State of California
Department of Water Resources
Sustainable Groundwater Management Program
Alternative Assessment Staff Report

Groundwater Basin Name: Napa-Sonoma Valley – Napa Valley (Basin No. 2-002.01)
Submitting Agency: Napa County
Recommendation: Do Not Approve
Date Issued: July 17, 2019

Figure 1. Napa County Groundwater Subareas in the Napa Valley Subbasin (From Basin Analysis Report, Figure 7-1)

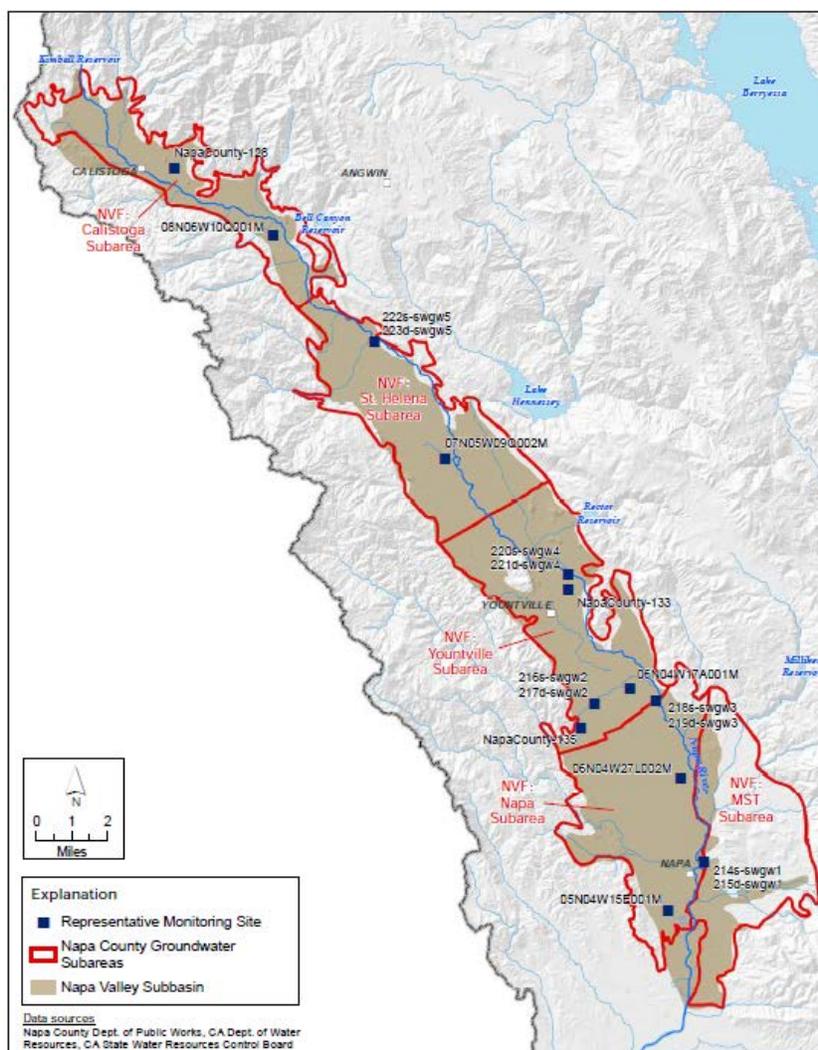
Napa County has divided itself into groundwater subareas for the purpose of local resource planning (see Figure 1, below). Five of these groundwater subareas make up the Napa Valley Floor and at least partially coincide with the Napa Valley Subbasin. The County discusses certain aspects of the basin setting in relation to these subareas. The subareas that are entirely included in the Napa Valley Subbasin are the Calistoga, St. Helena, Yountville, and Napa subareas. The subarea that is partially included in the Napa Valley Subbasin is the Milliken-Sarco-Tuluca (MST) subarea.³²

Minimum thresholds for sustainability indicators do not appear to include the MST area and no representative monitoring includes the MST area. The monitoring network section provides a description of groundwater monitoring for the entire county in 2015. Napa County categorizes monitoring areas by local groundwater subareas. The subareas corresponding to the Napa Valley Floor approximately align with the Napa Valley Subbasin as defined by Bulletin 118 except for the Napa Valley Floor – MST Subarea (MST area). The MST area does not align well with the boundaries of the Subbasin. Because of this lack of alignment, it is unclear which wells in the MST area are within the Napa Valley Subbasin and which wells are not. Two monitoring wells in the MST area are used as representative monitoring wells for plotting hydrographs and occur within the Napa Valley Subbasin. However, neither of the wells are used to set minimum thresholds despite showing declining water levels and different trends from the other areas of the Subbasin. The Basin Analysis Report does indicate there are efforts to further investigate the MST area; however, these efforts were not completed by the statutory deadline for submitting an alternative to the Department.
